World Forum for Harmonization of Vehicle Regulations**Working Party on General Safety Provisions****127th session**

UN Regulation No. 118 (Fire resistance of interior materials)**Proposal for the Supplement 3 to the 03 Series of
Amendments to UN Regulation No. 118 (Fire resistance of
interior materials)****Submitted by the expert from the European Association of Automotive
Suppliers ***

Insert new paragraph 4.4.3.1., to read:

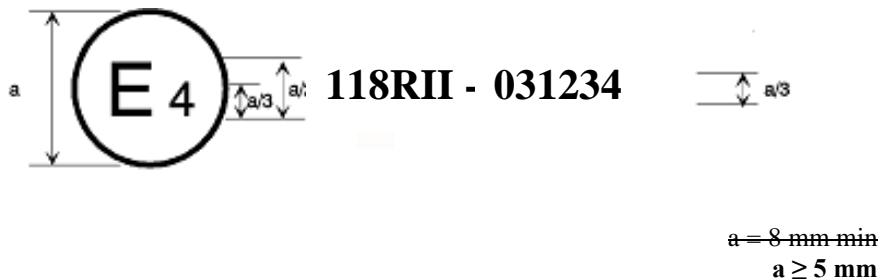
"4.4.3.1. If the component conforms to a component type approved, under one or more other Regulations annexed to the Agreement, in the country which has granted approval under this Regulation, the symbol prescribed in paragraph 4.4.1. above need not be repeated; in such a case, the Regulation and approval numbers and the additional symbols of all the Regulations under which approval has been granted in the country which has granted approval under this Regulation shall be placed in rows to the right of the symbol prescribed in paragraph 4.4.1. above."

"Example 2

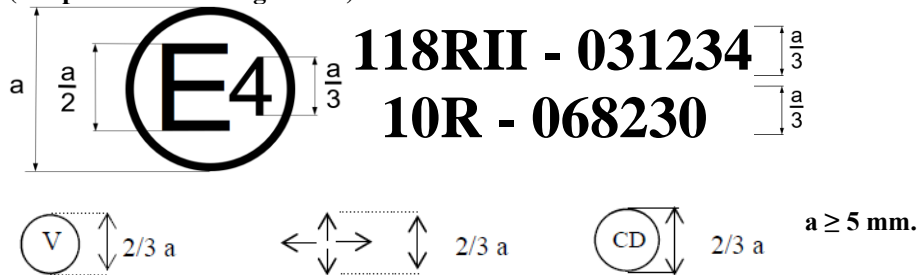
The above approval mark affixed to a component shows that the type concerned was approved in the Netherlands (E4) pursuant to Part II of UN Regulation No. 118 under approval number 031234. The first two digits (03) of the approval number indicate that the approval was granted in accordance with the requirements of the 03 series of amendments to UN Regulation No. 118.

4. The proposal also clarifies the (missing) dimensions of the symbol as in the case of the current Example 2 by adding $2/3a$ to its right.
